**WS 1. 12/5/23
Presentation**

PUBLIC WORKS STANDARDS

Technical
Amendments

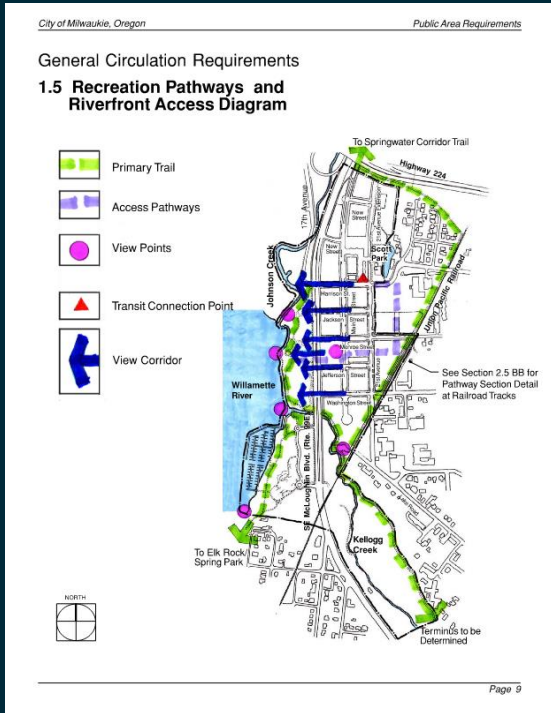
- Does not include Trolley Trail
- Pathway adjacent to railroad tracks is now the Max Orange line system
- Transit connection is on Jackson Street instead of Harrison Street
- Does not include Monroe Street Greenway
- Access pathway between Monroe Street and Jefferson Street goes through a building

1.9 Transit Routes Diagram

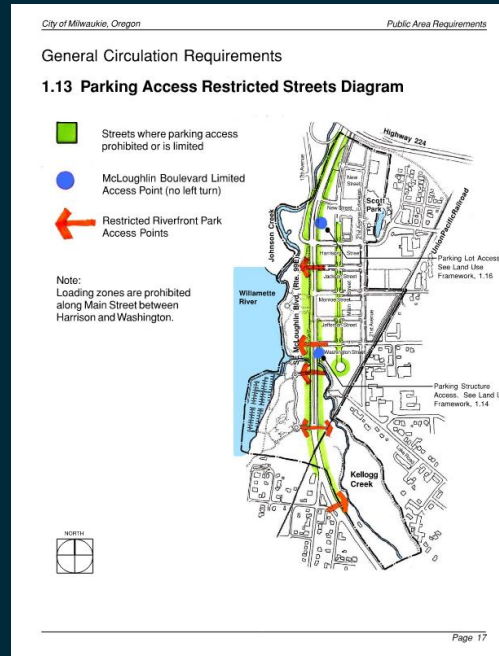
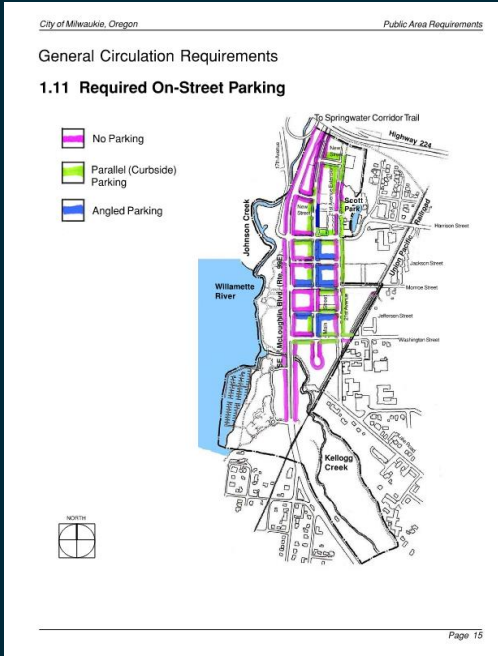
Does not show 17th Ave Path, Trolley Trail or Shared lanes on Main Street

Transit Center on Jackson Street

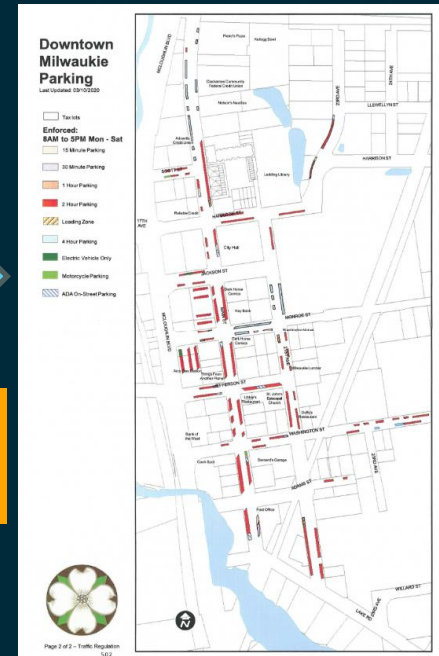
Superseded by
Traffic
Regulation 502

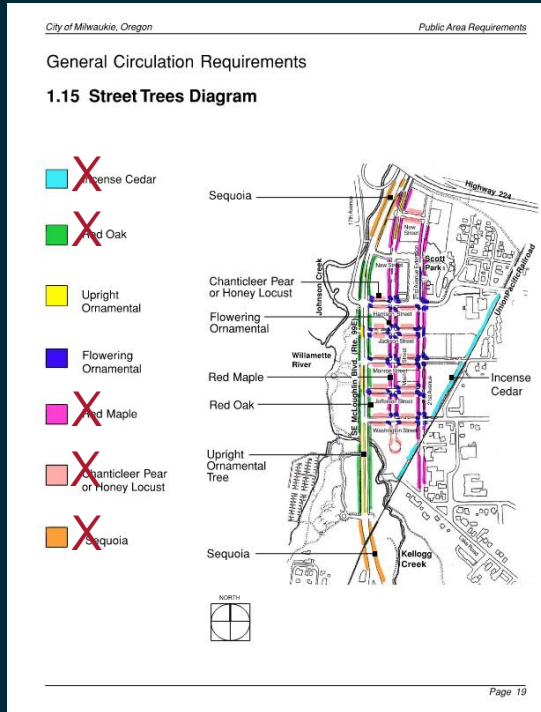
~~Japanese Cherry (Prunus serrulate 'Kwanzan')~~

On Approved Tree List: Columnar Hornbeam (Carpinus betulus 'Fastigata')
